ADMINISTRATIVE AMENDMENT (FPA) ADD2014-00102

**ADMINISTRATIVE AMENDMENT
LEE COUNTY, FLORIDA**

RE: **MIROMAR LAKES MPD/DRI ADD2014-00102** DS SUFFICIENCY REVIEW COMMENTS

RIP-RAP EXHIBIT

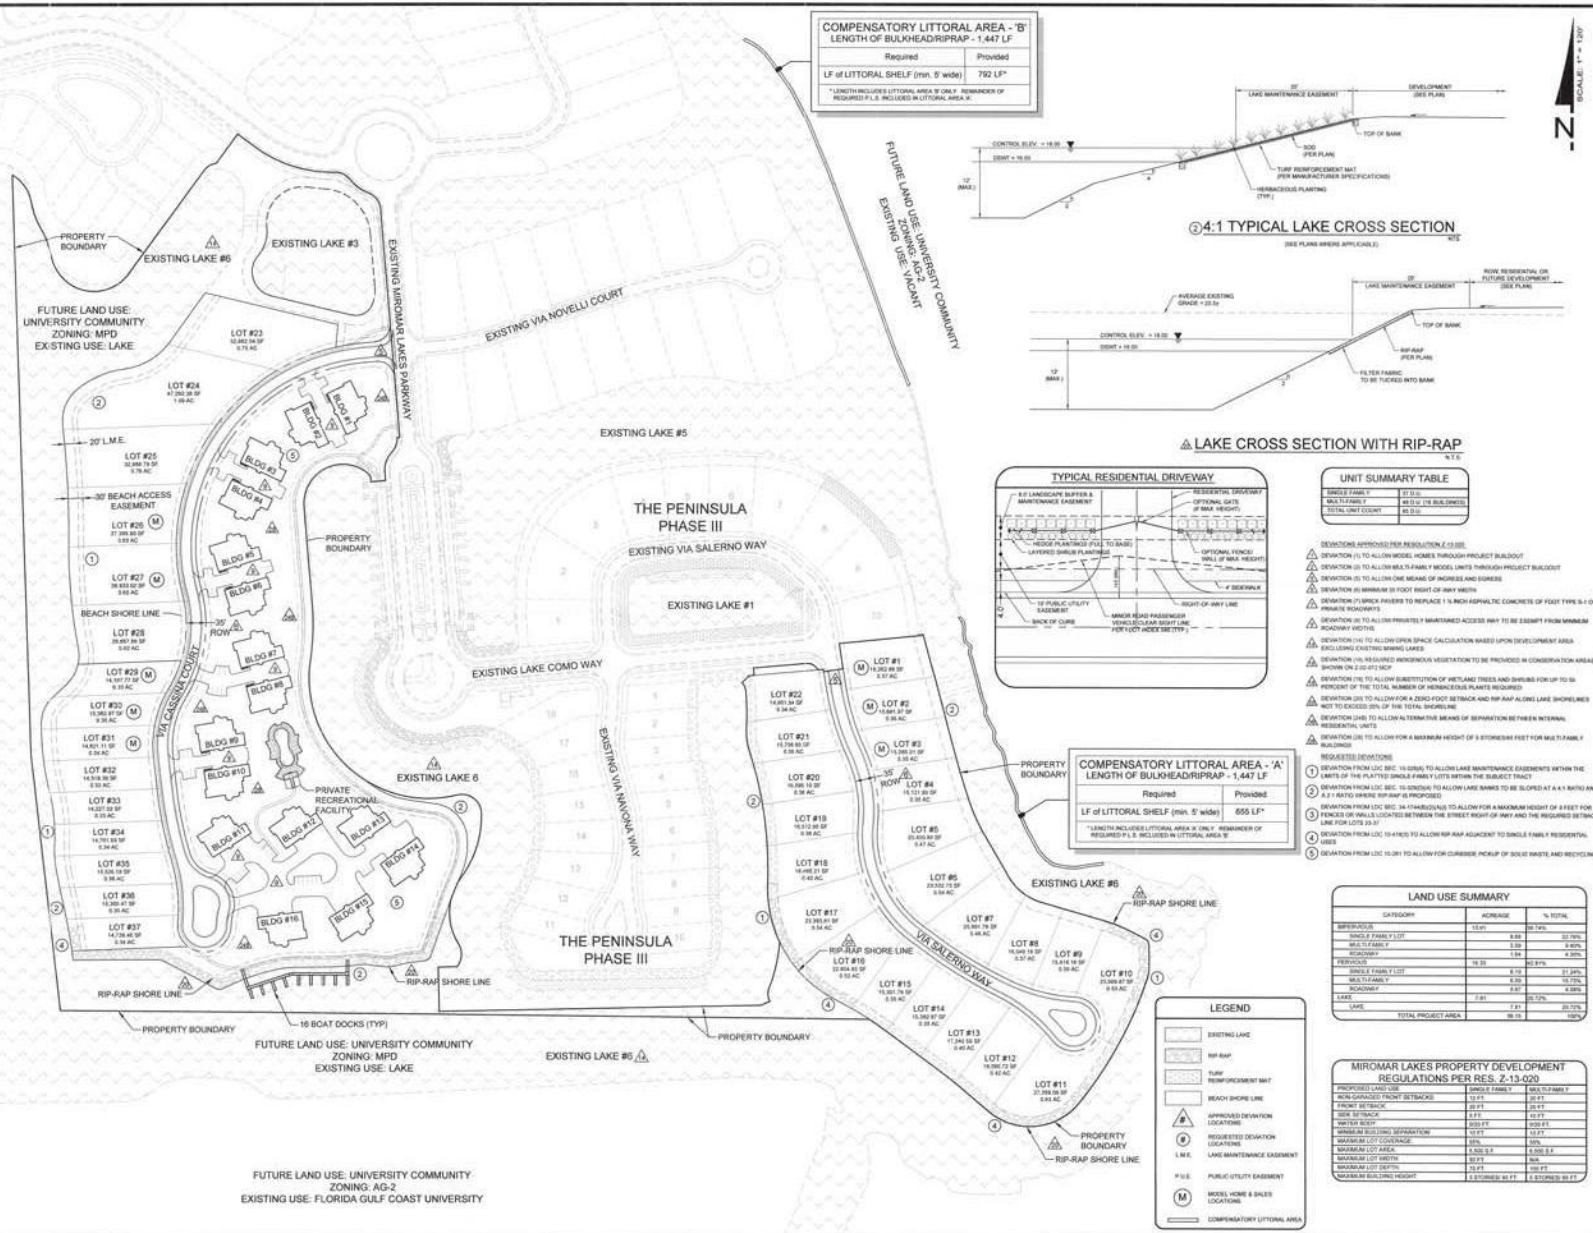
Staff understands that previous approvals limited the rip-rap shoreline to certain areas with a maximum amount. Please update the rip-rap exhibit attached to ADD2012-00110 as necessary. Due to the existing nature of the tract and the constraints of the existing lake, and previous deviation approvals, DS staff has no objection. At the time of development order, please show that this limitation has not been exceeded.

Note that rip rap is not allowed adjacent to SFR development (10-418). A deviation may be required
